# **Flex PLI Inverse Test Setup - Moving Ram Friction**

**Dirk-Uwe Gehring  
BGS Böhme & Gehring GmbH  
5<sup>th</sup> Meeting of the IG GTR9-PH2  
Bergisch Gladbach, Germany, December 2012**

- Document GTR9-4-11e.pdf:  
Concept Tech, Austria: Investigation of the Influences of Friction within the Inverse Certification Test Setup of the FlexPLI.
- Action item from 4th meeting of IG GTR9-PH2:  
Measure the friction at the test stands and/or provide comments to the Concept document

## Review of certification data:

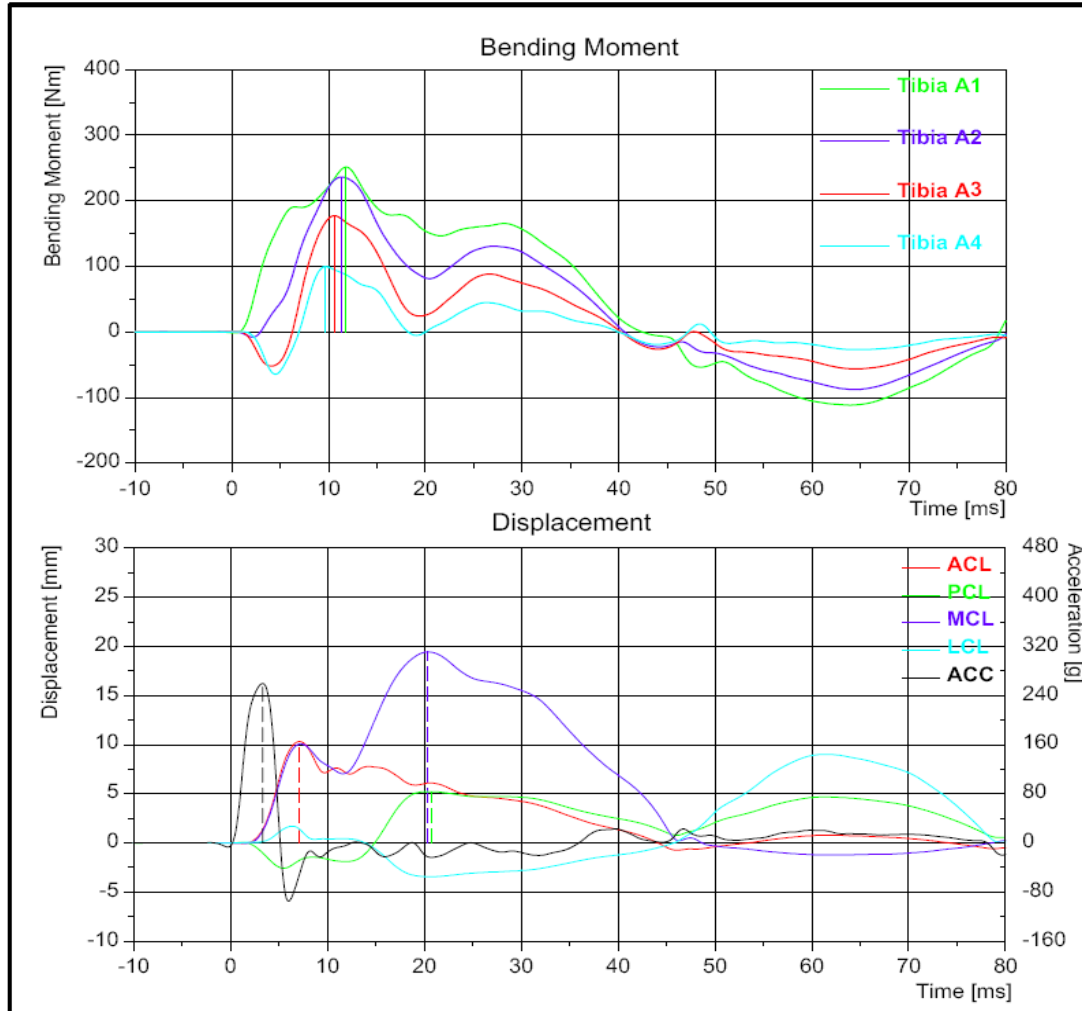
- Maximum values occur up to ca. 20 ms, i.e. any effect occurring after 20 ms is irrelevant
- Influence and relevance of friction within 20 ms is unclear, but assumed to be negligible due to the short time

- Speed measurement should be taken immediately before impact (distance approx. 0 mm) to avoid any influence of friction or any other speed influencing factor before impact.
- In case of smooth-running bearings there seems to be no need to set any additional requirements on the friction
